MIL-F-44434(GL)
AMENDMENT 1
12 August 1992

FLASHLIGHT, LIGHTWEIGHT

FIGURE 1
FLASHLIGHT CONFIGURATION

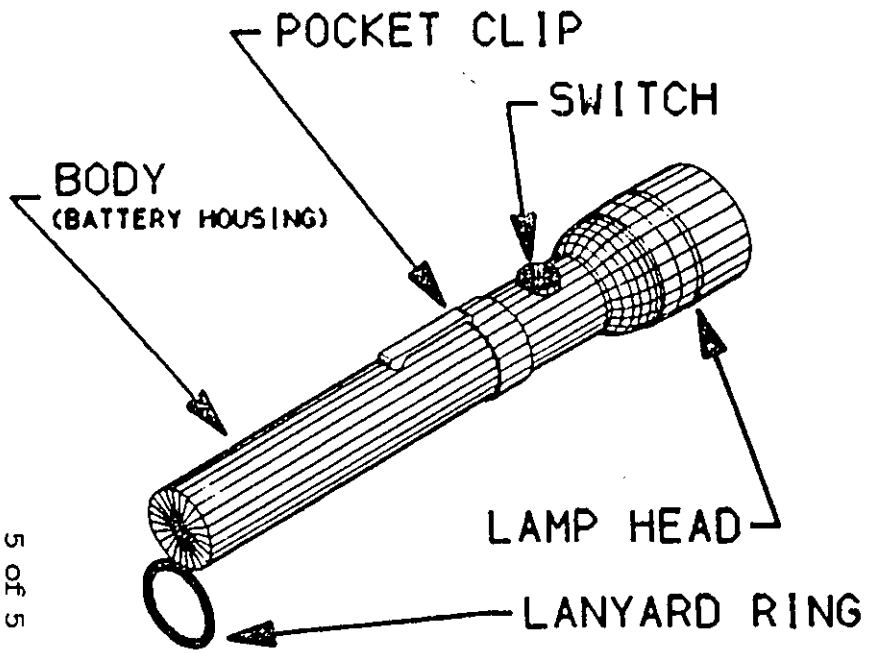
3.13: Delete and substitute:

"3.13 Size/Configuration. The flashlight shall be configured as shown in figure 1. The flashlight shall be cylindrical in shape with a total volume not to exceed 5.0 cubic inches, and shall have a maximum overall length of 6.5 inches. The body (battery housing) and lamp head shall have maximum diameters of 0.85 and 1.135 inches respectively. The lanyard ring shall be attached to the body at the end opposite the lamp head. The pocket clip shall have at least 1 inch of reach. The near end of the pocket clip shall be attached to the body at a point between 2.0 inches and 2.5 inches from the lamp head end of the flashlight. The switch shall be located on the outside of the body of the flashlight directly behind the head of the flashlight as shown in figure 1."
